Board of Directors Meeting Staff Report

SUBJECT: **Consider Approval of Resolutions 2021-05 and 2021-06 to Certify the 2021 Final Supplemental Environmental Impact Report (SEIR) for the Proposed Modifications to the Pure Water Monterey Project and to Conditionally Approve the Proposed Modifications**

COMMENTS FROM RECYCLED WATER COMMITTEE MEETING

Figure 3: Reduced Demand = Reduced WWTP Flow (=Reduced Recycled Water Supply)

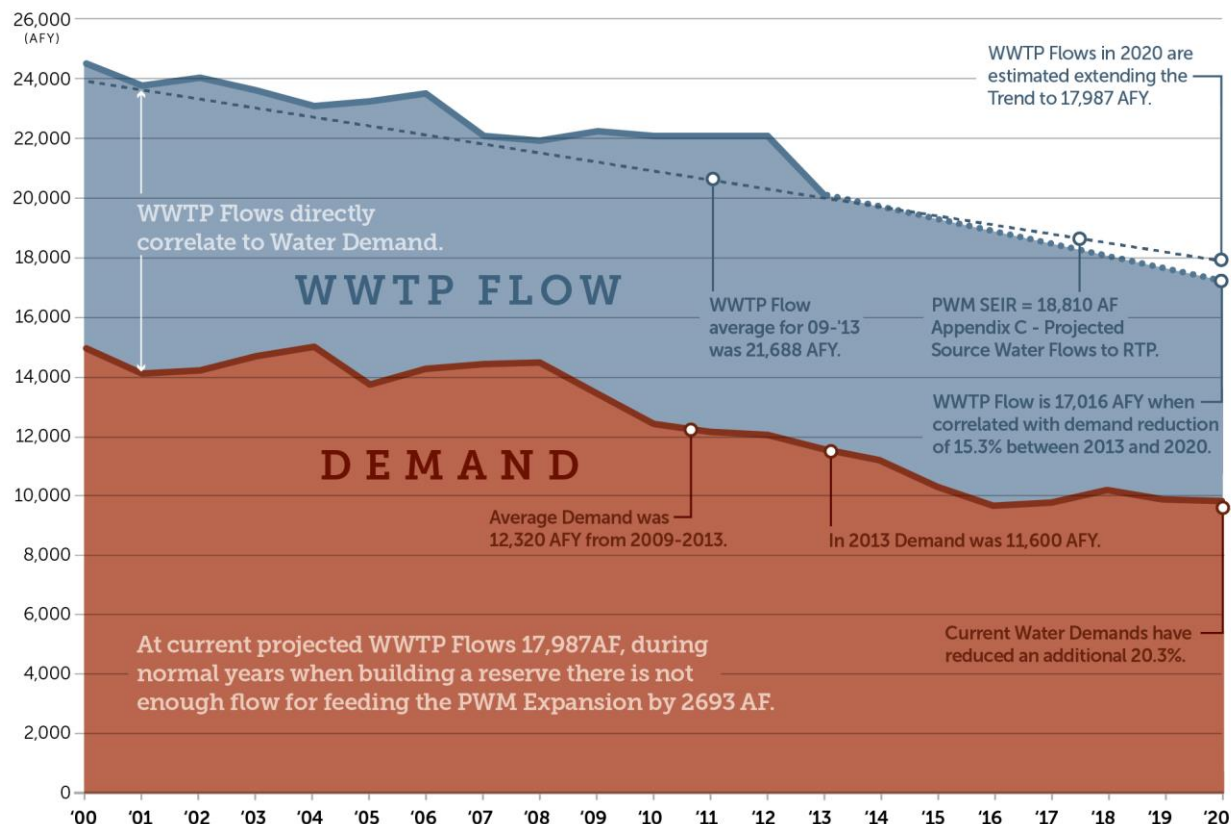
The approach taken in Appendix I ignores that WWTP flows correlate to water demand/use, which has continued to decrease on the Peninsula due to conservation and other factors. Based on available data, Figure 3 below depicts an overall downward trend in WWTP flows that is consistent with the observed decline in water demand on the Peninsula. The EIR from 2016 for PWM Phase One shows WWTP flows trending downward from approximately 25,000 AF in 2000 to approximately 20,000 AF in 2013.⁸ A separate appendix to the Supplemental EIR (Appendix E) shows further reduced WWTP flows to 18,810 AF (16.79 MGD).⁹ However, this number was not utilized in the Supplemental EIR to calculate available WWTP flows as source water for either PWM Phase One or PWM Expansion, which is a significant error.

Figure 3 shows that the WWTP Flows correlate with demand reductions on the Peninsula. For example, as shown in Figure 3, since 2013 demand has declined 20.3% when compared to the average demand from 2009 to 2013. Additionally, 2013 drought year demand compared to current demand, represents a 15.3% reduction.¹¹ Calculating the WWTP flows over these same time periods using these respective reduction percentages (20.3% and 15.3%), a conservative estimate of current average WWTP flows is 17,296 AF to as low as 17,016 AF, respectively. An alternative method of determining today's WWTP flows based on a linear trend of the existing flow data indicates that current flows are 17,987 AF, as shown in Figure 3. All of these WWTP flow estimates, which are based on a more complete picture of recent data, are much lower than those used in the SEIR Appendix I - Tables 8 to 11. As result the SEIR substantially overstates the availability of WWTP flows available as source water available to PWM Phase One and the PWM Expansion.

Figure 4: Impacts of Demands Exceeding Limited Supplies

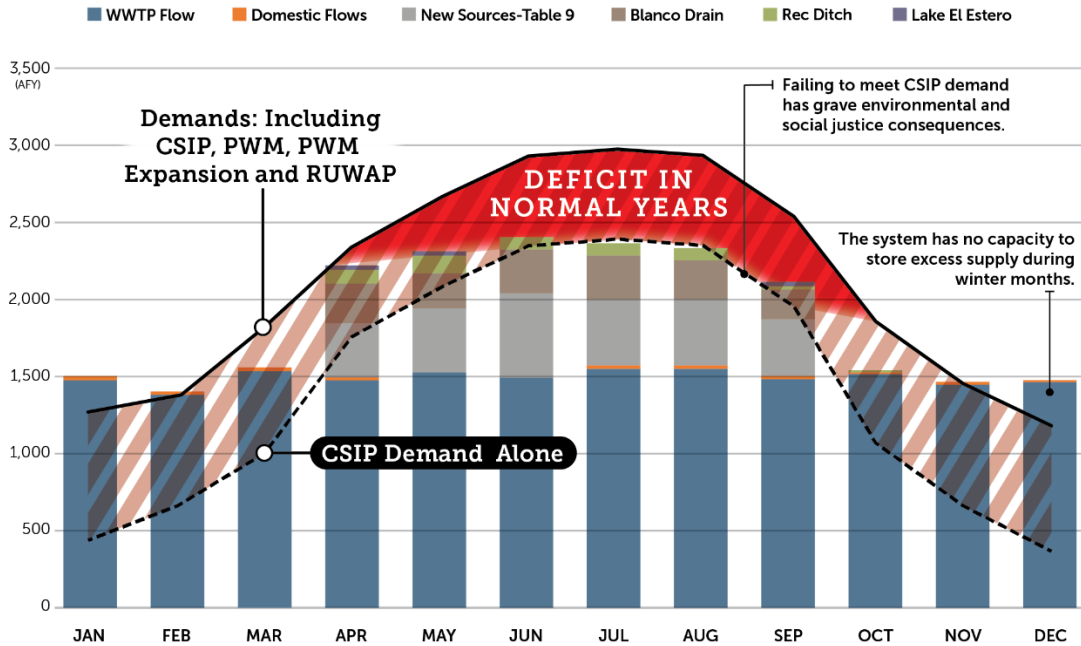
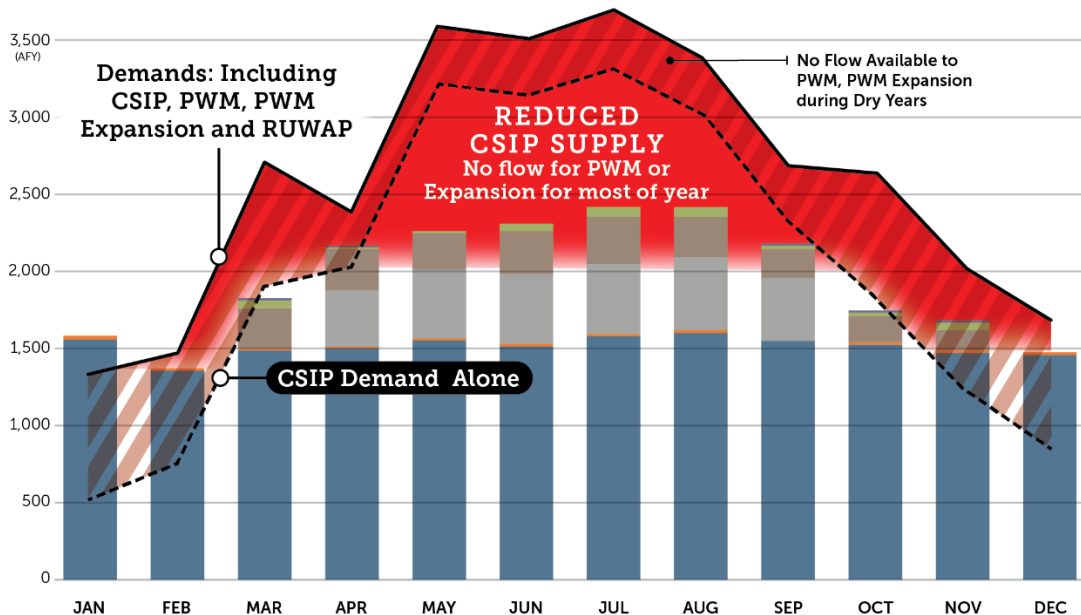
The combined analysis of supplies and demand illustrated in Figure 4 below (Normal/ Wet Year Building ASR) and (Dry Year) are based on monthly supply and demand from SEIR Appendix I-Tables 9 and 11 with data updated as noted in Table 1 above. Figure 4 shows that when lower WWTP Flow from Figure 3 and lower Reclamation Ditch flows from Table 3 and all other available sources are accounted for, that demand for those specific source waters far exceeds available supplies in Normal/Wet Years and in Dry Years.

As shown in Figure 4 above there is a demonstrable water deficit. Monthly supply of water as compared to demand even when the additional proposed supplies of Agricultural Wash Water, Urban Runoff, Blanco Drain, and Reclamation Ditch are included does not satisfy the demand during a significant portion of the year – particularly during the summer months.

Figure 5: Supply Available for PWM Expansion or CSIP (Not Both)

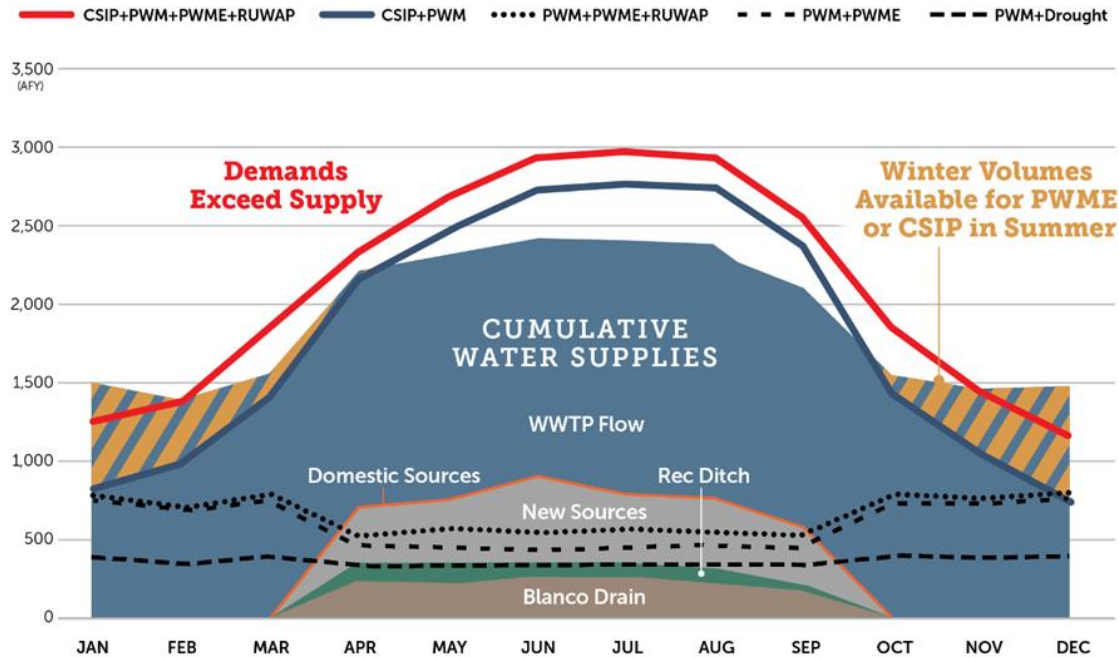
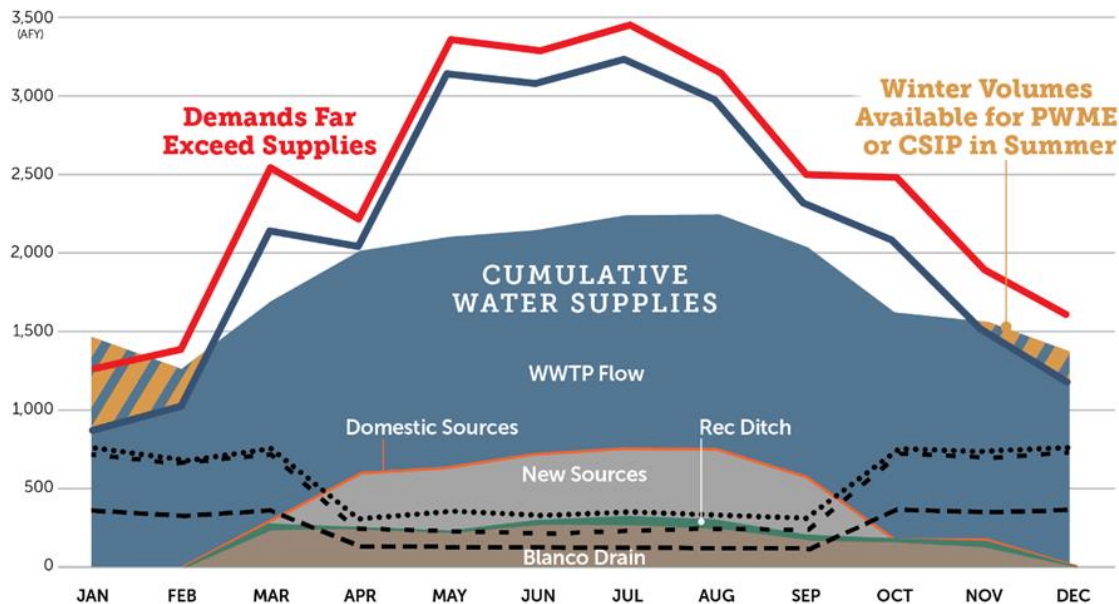
Figure 5 closely correlates the cumulative water supplies to the respective cumulative demands. The water supplies are shown in the order of use with the PWM Phase One using Blanco Drain and Rec Ditch. Based on agreements, such as the Amended and Restated Water Recycling Agreement between the M1W and the Monterey County Water Resources Agency, those flows are unavailable to the PWM Expansion. Then New Sources are added to serve as the supplies for the PWM Expansion according to the priorities and water rights as defined in SEIR Appendix M. The supplies are cumulative by month. The graphs are based on SEIR Appendix I -Table 9 and 11 with the WWTP and Reclamation Ditch flows updated. These graphs include Lake El Estero and AWW, which are now not included in the water supply as noted in SEIR Appendix M as a best-case supply scenario (SEIR Appendix M-Page 5).

Figure 5 demonstrates that in normal years, excess winter effluent that would ultimately go to the Ocean can be used or it is otherwise wasted. However, with current CSIP demand the system will always be in a deficit. If CSIP could capture winter flow (such as the proposed but not implemented improvements to the Salinas Valley Reclamation Project (SVRP) (SEIR Master Response #3 p. 3-20, SEIR Appendix M- Page 5)) to run SVRP and CSIP at lower flows without using wells in conjunction with water storage or groundwater infiltration, then excess winter water could be available for use in the summer for CSIP. Implementing such a storage program would be a sizable new development project and would require a significant investment to secure and develop the necessary property where the storage program could be implemented (such as a reservoir). Further, for CSIP and CSIP well demands in SEIR Appendix I Tables 9-11 to be met, this would require all of the other New Water sources, Blanco Drain and Reclamation Ditch as well to meet the combined CSIP and CSIP well flows now and especially in dry years.

**Updated Figure 3:
Reduced Demand = Reduced WWTP Flow
(=Reduced Recycled Water Supply)**

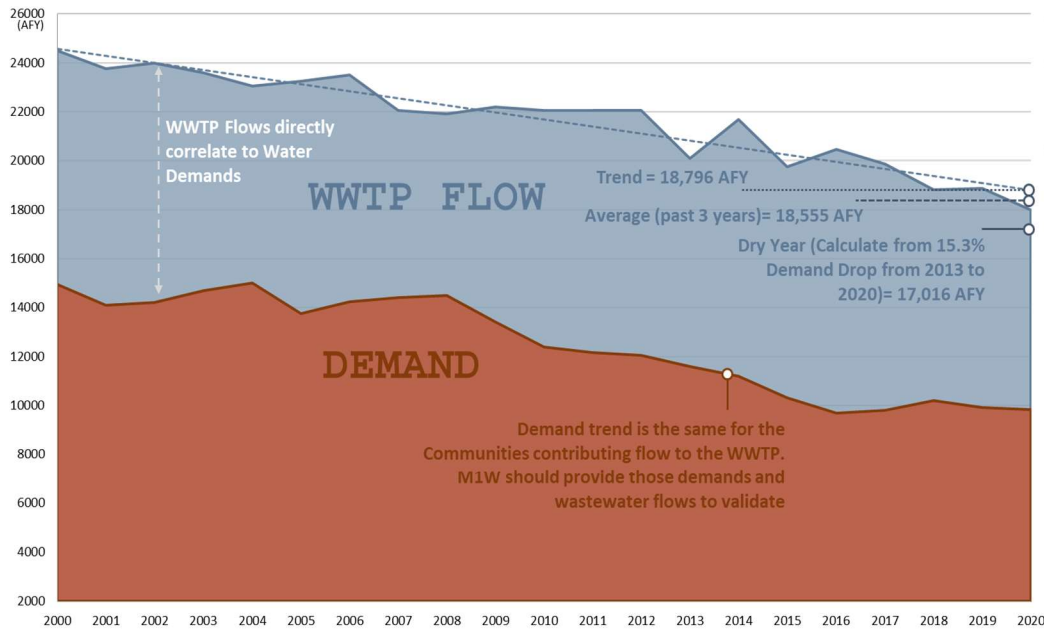
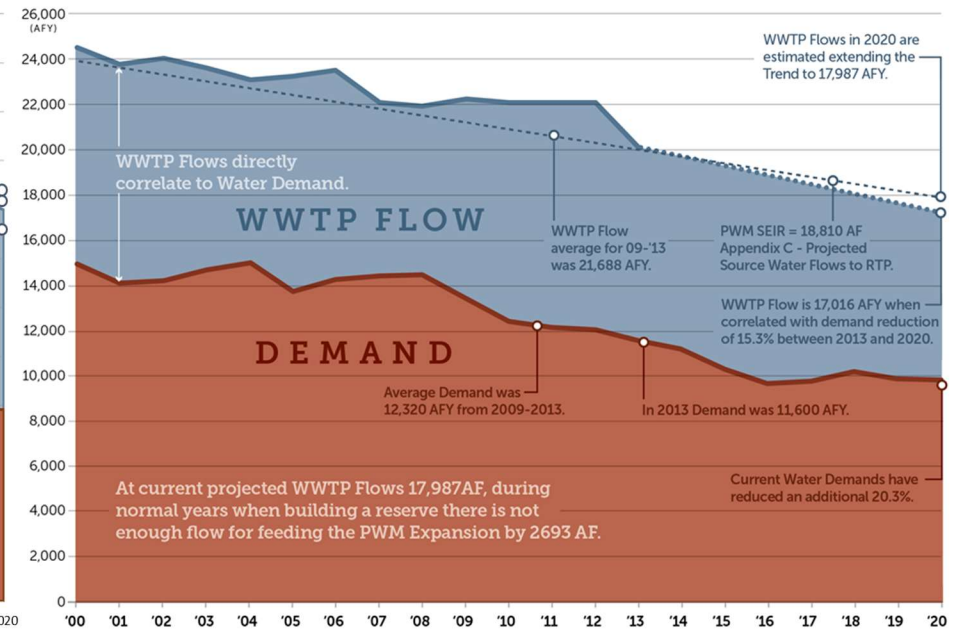
- The SEIR for the PWM Expansion has never been updated to account for either the 2018 flow of 18,810 AF, or the 2020 flow of 17,980 AF, much less the new flow data that M1W has just provided. When accounting for the new flow information, the slope of the decreased flows since 2013 is very similar to the declining trend that Hazen previously projected (see Updated Figure 3). In fact, M1W's new flow information is confirmation of the trend that Hazen presented and further demonstrates that source water for the PWM Expansion is inadequate.

The Latham and Watkins letter and Exhibit 2 appears to contain inaccurate analyses and conclusions regarding sources of supply and yields for the PWM Project and the possible PWM Expansion, as proposed by others. In Exhibit 2, Figure 3, Hazen & Sawyer showed a decline in influent wastewater flow volumes from 2000 to 2013, and using that historic and incomplete influent data, they project 2014 through 2020 volumes using a trend line (linear extrapolation). The incorrect resultant wastewater flows in 2020 of 17,016 acre-feet per year (AFY) permeates into analysis throughout the remainder of the report. Figures on pages 12, 14, and 20 and associated text in Exhibit 2 are based on multiple inaccuracies (see also Surface Water Limitation which further falsify these charts). Actual flows since 2013 are shown below.
